**SISHEN MINE GROUNDWATER INVESTIGATION REPORT**  
**NW – ZONE**

**C. Lasher and J.M Nel**

The UNESCO Chair Centre for Geohydrology was appointed by the Department of Water Affairs and Forestry to evaluate a report by Golder Associates with title *Sishen Mine Groundwater Investigation Programme – NW Zone Report* (Report no 5157/6867/4/G) dated August 2005.

**Figure A** Satellite image of possible groundwater flow lineaments in the area southwest of Sishen mine.

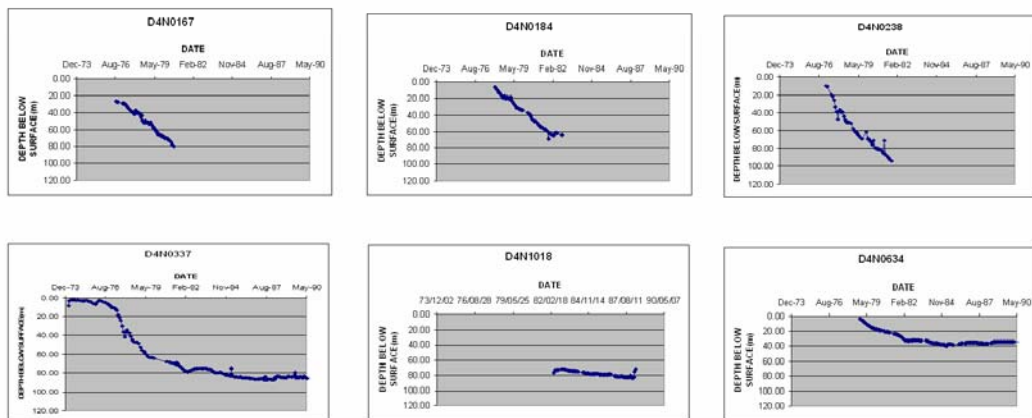
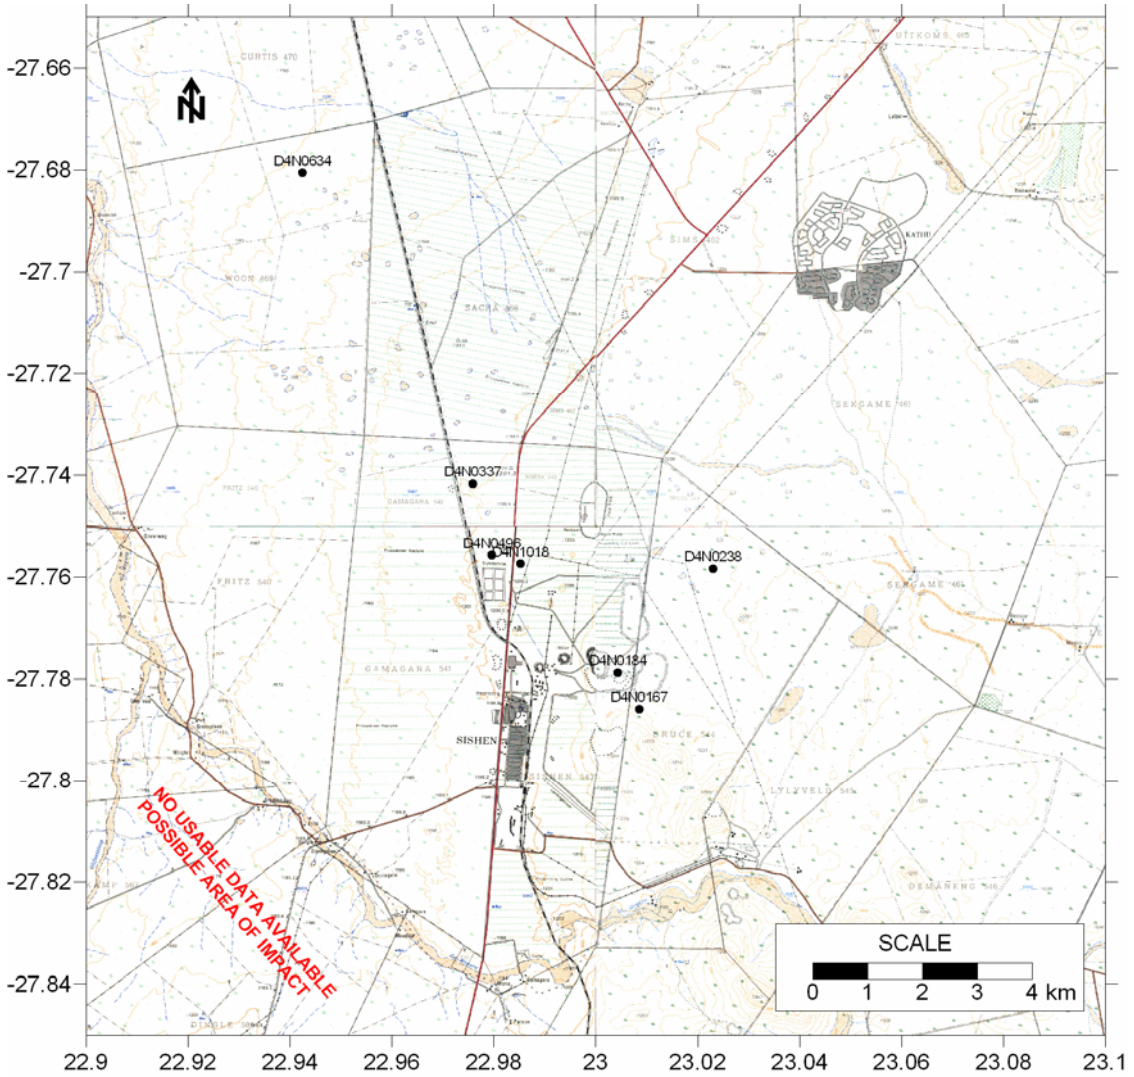
If we consider the satellite imagery for the area southwest of Sishen mine (Figure A) we will notice several very prominent SW-NE striking lineaments.

These lineaments might be groundwater barriers for flow across them under natural flow conditions in a northwest direction (Dziembowski et al., 1979) or like when an aquifer test is performed with observation holes on the other side. But when flow directions are changed due to the dewatering of the mine pit, these lineaments might become high transmissive conduits to flow due to flow along them instead of across them. The very flat water level contours (Figure 10) in this zone supports this possibility. Water users along these lineaments will be affected by the mine. The groundwater users in this area are mainly farm owners and terrestrial ecosystems.
